# IFB 2015-0001 - ADDENDUM 1

## HONEY HORN DRIVEWAY PROJECT Town of Hilton Head Island, South Carolina

Date Issued: February 9, 2015

**Item 2. Please use the revised bid schedule dated 2-9-15 and the revised plan sheets SD-1 and GP-1 as revised on 2-6-15.**

DWG. NO. SD-1

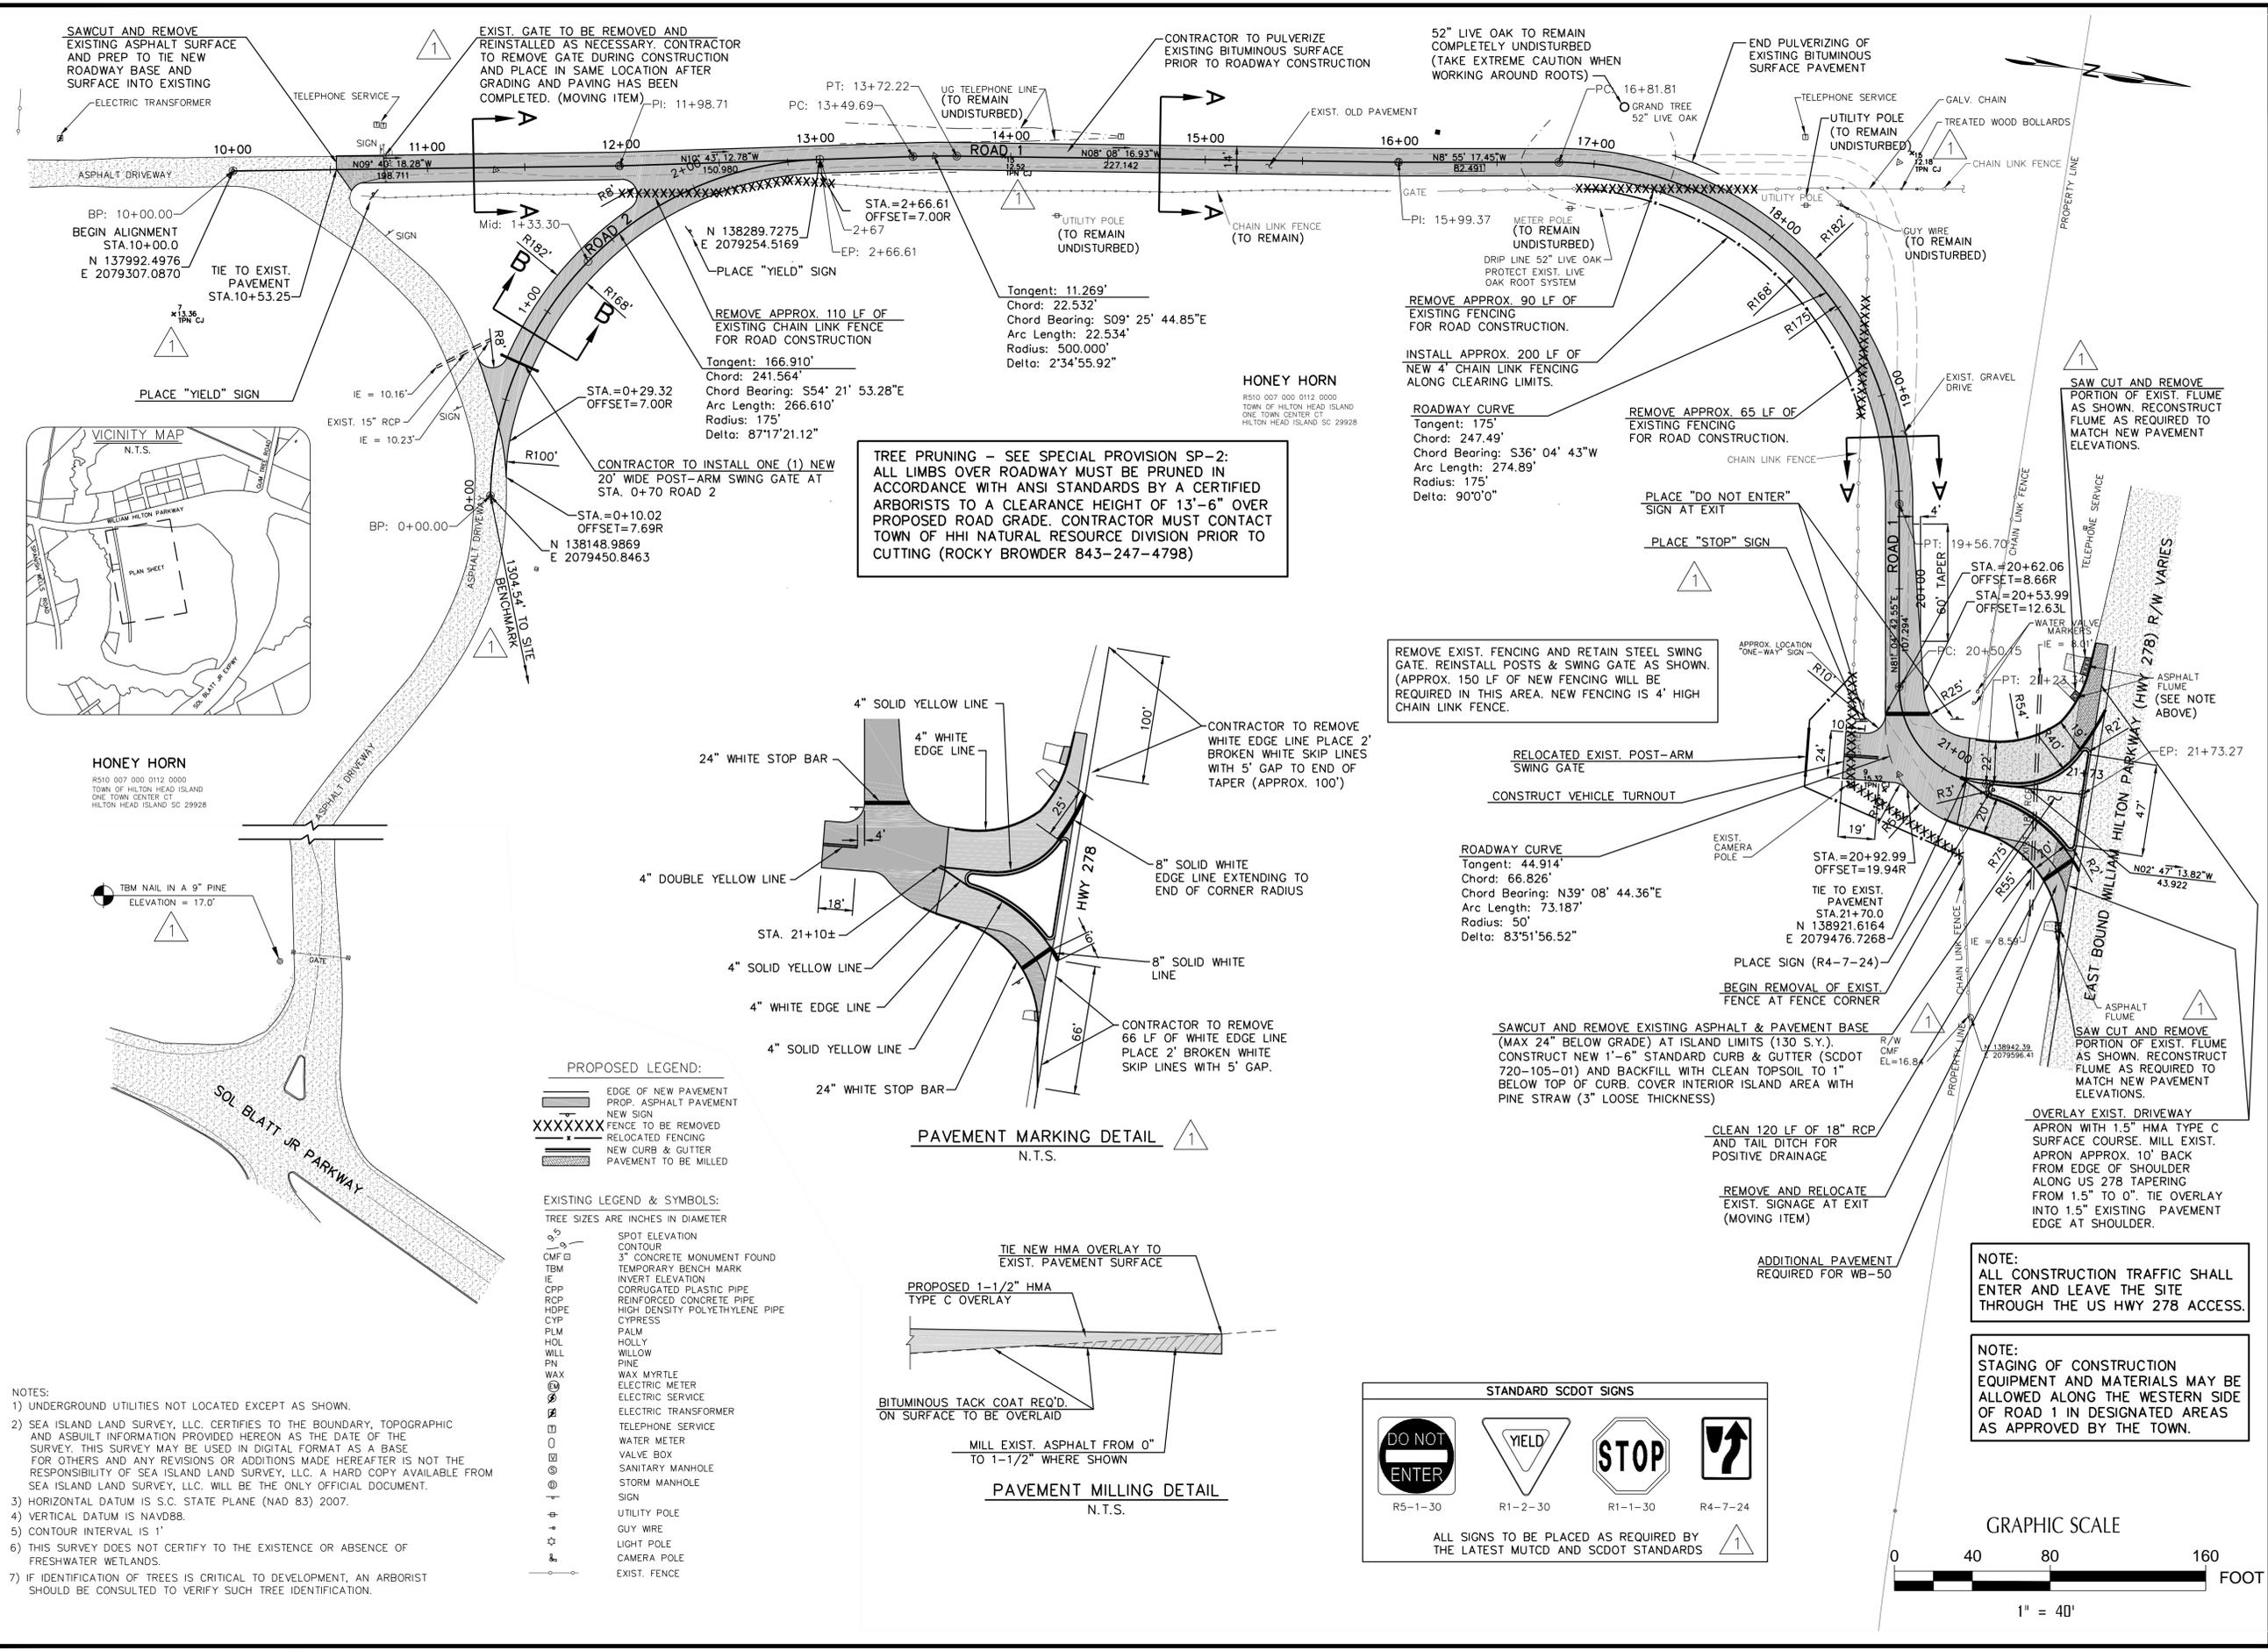
Q1: The 35 SY of pavement removal for the splitter island appears to be low. There is also pavement removal called out at the pavement joint (Sta. 10+53) and there are two notes along ROAD 1 which say "remove bituminous surface".

Q3: The plans show 200 LF of new fencing (4' chain link) to be installed on the inside of the new curve, from Sta. 17+00 to Sta. 19+00, but there is no line item on the bid schedule.

Q4: The plans [Sheet SD-1] require the contractor to remove and reinstall the existing gate near Sta. 10+80, but there is no line item on the bid schedule.

Q5: The plans [Sheet SD-1] require the contractor to remove and reinstall a portion of fence and a "NEW 24'" swing gate at the asphalt apron near Sta. 21+00, but there is no line item on the bid schedule.

A1: The Plans and the Bid Schedule have been revised to reflect correct quantities. The existing surface of road is gravel and there is no pavement to remove. Removal of the gravel should be covered under unclassified excavation.

A3: A line item has been added to the Bid Schedule to account for 200 LF of 4' chain link fence (SCDOT Spec 8063100)

A4: A line item will be added to the bid schedule to account for this work as a MOVING ITEMS (SCDOT Spec 8081000)

A5: A line item has been added to the Bid Schedule to account for this work as a MOVING ITEMS (SCDOT Spec 8081000). The plan note was revised for clarification that the EXISTING swing gate shall be relocated. The only NEW 24' swing gate is to be installed at approximately Sta. 20+45 across ROAD 1.

DWG. NO. GP-1

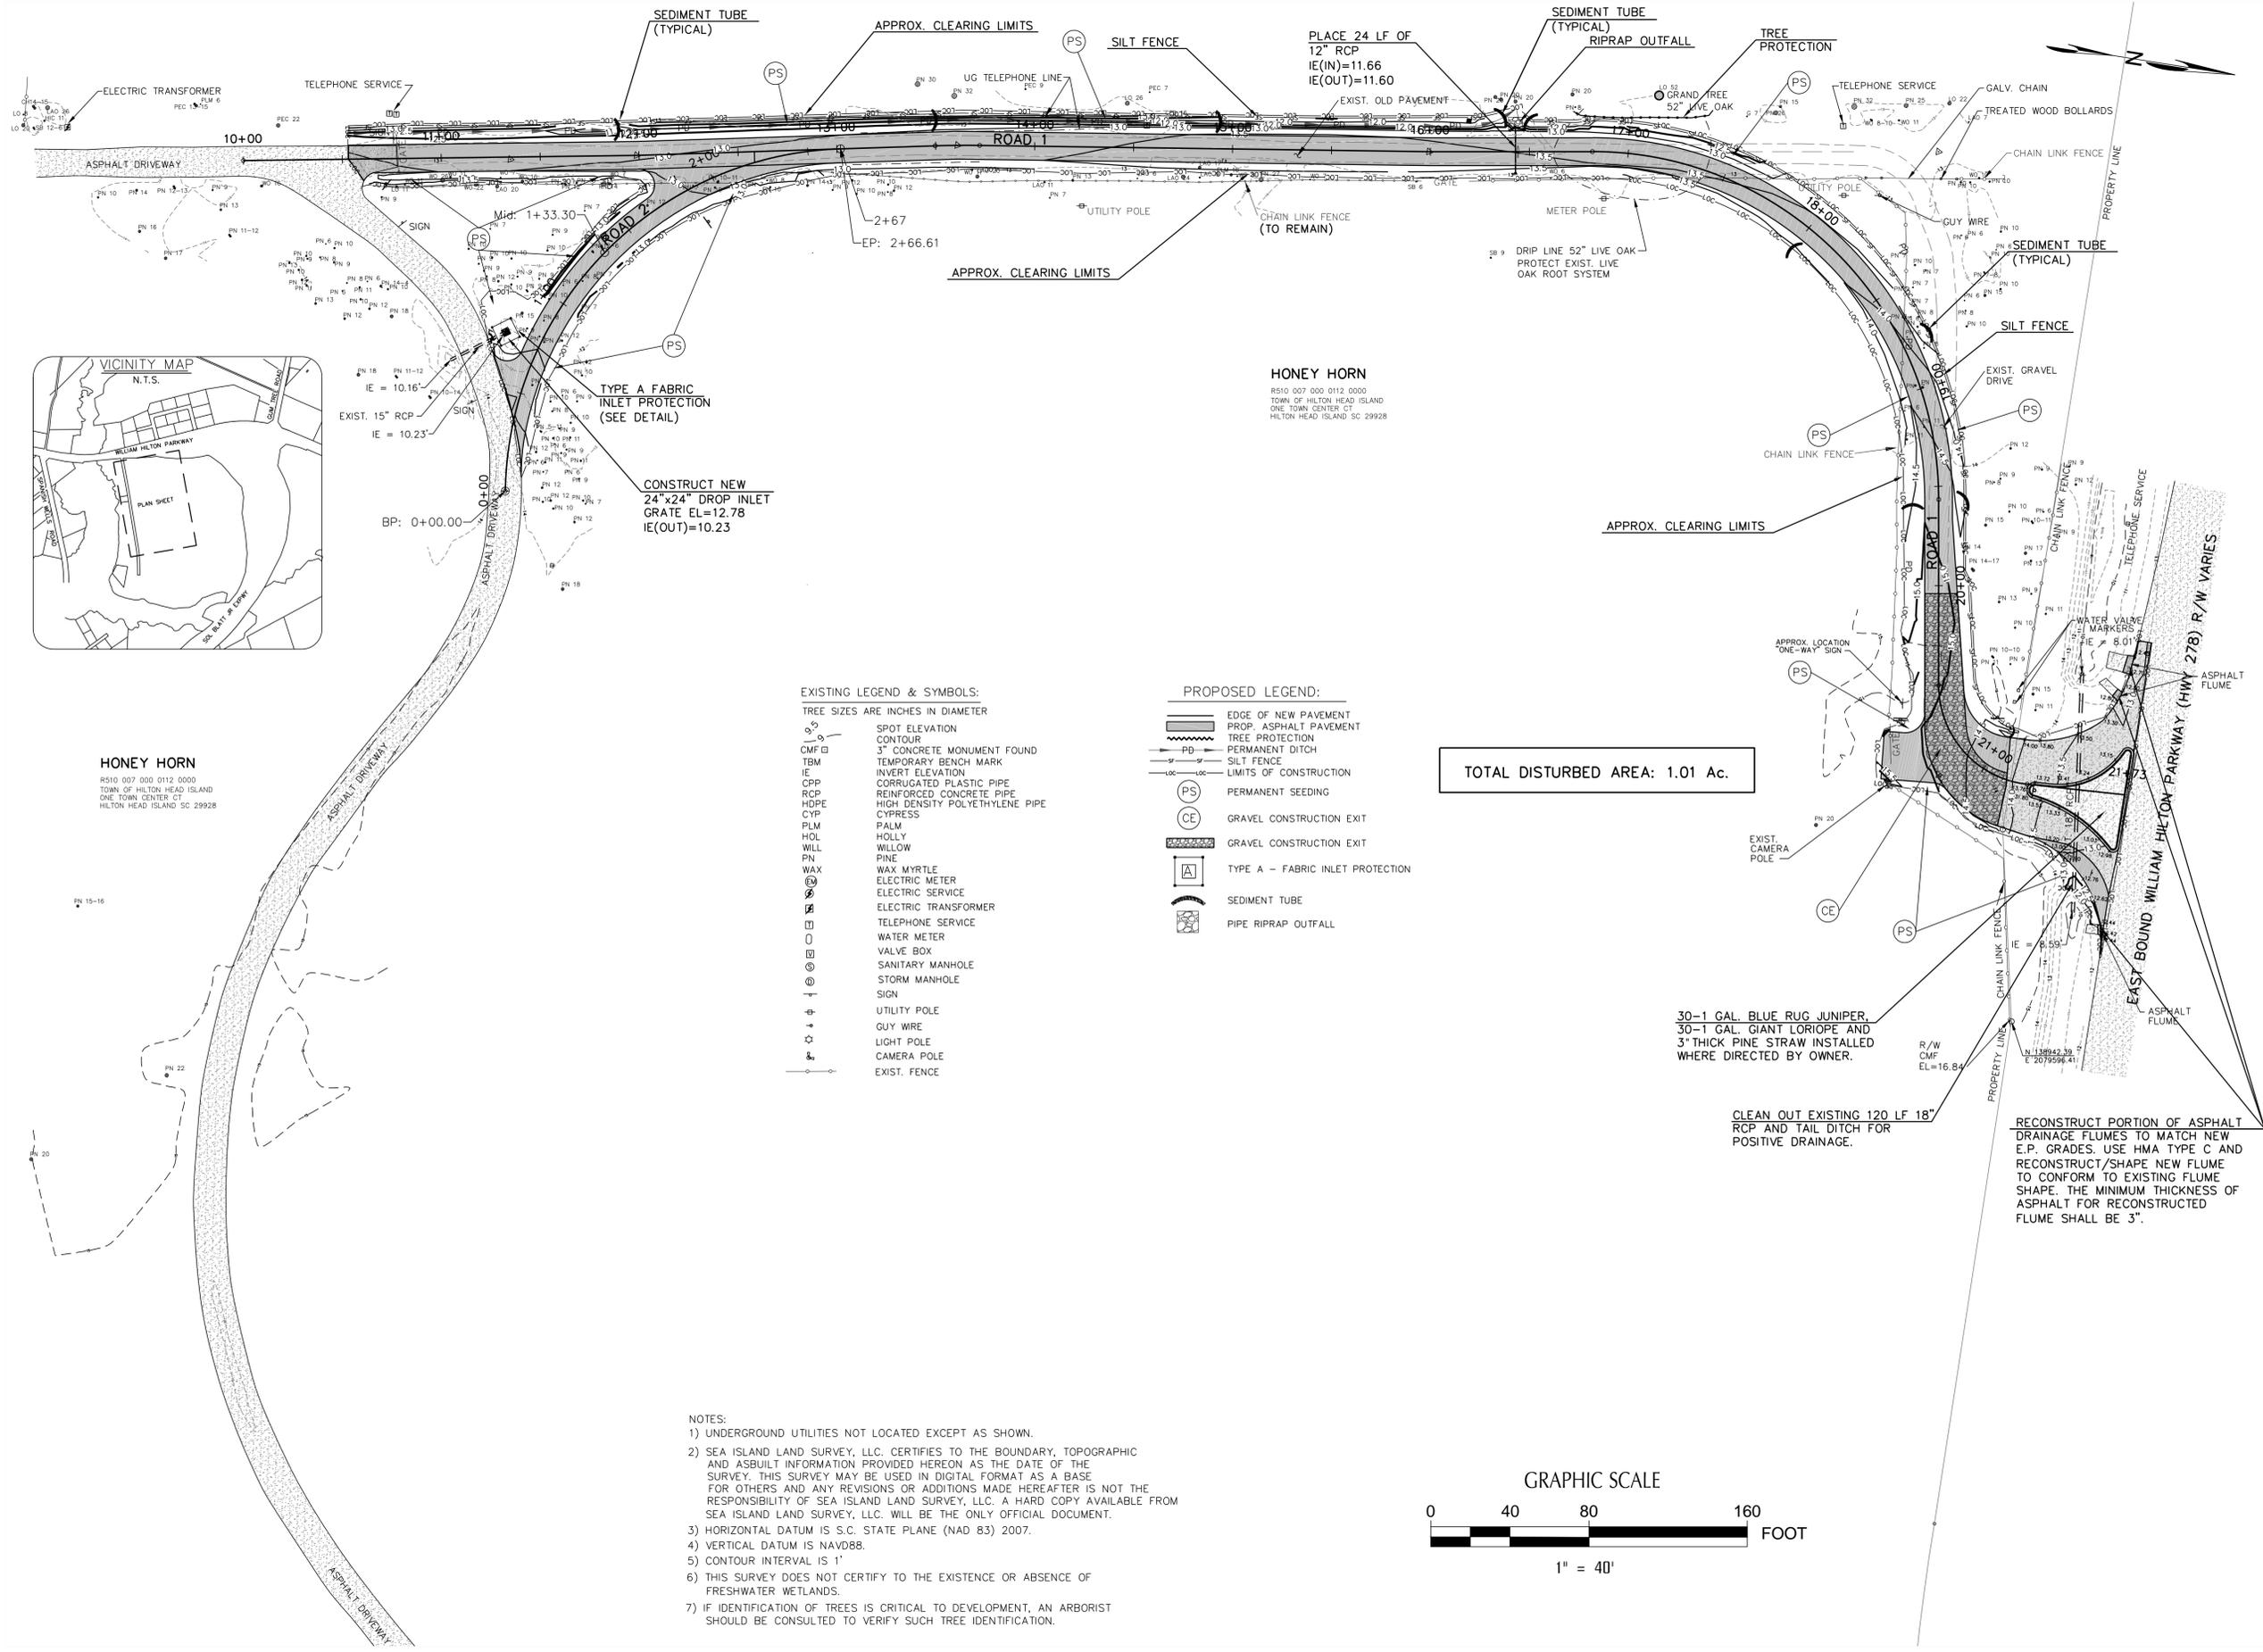
- Q6: On sheet GP-1 there is a note to clean existing pipe and tail ditch for positive drainage, but there is no line item on the bid schedule.
- A6: A line item has been added to the Bid Schedule to account for cleaning 120 LF of 18" RCP (SCDOT Spec SC-M-7149999). Tail ditching is covered under Unclassified Excavation.
- Q7: The brown vinyl coating specified for the steel gates will require significant lead time and is not likely to be produced and delivered within the 30-day performance time. Powder coating was recommended as a cost-effective substitute.
- A7: This special provision has been changed to delete the vinyl coating and replace with dark brown powder coating.

CLEAN OUT EXISTING 120 LF 18"  
 RCP AND TAIL DITCH FOR  
 POSITIVE DRAINAGE.
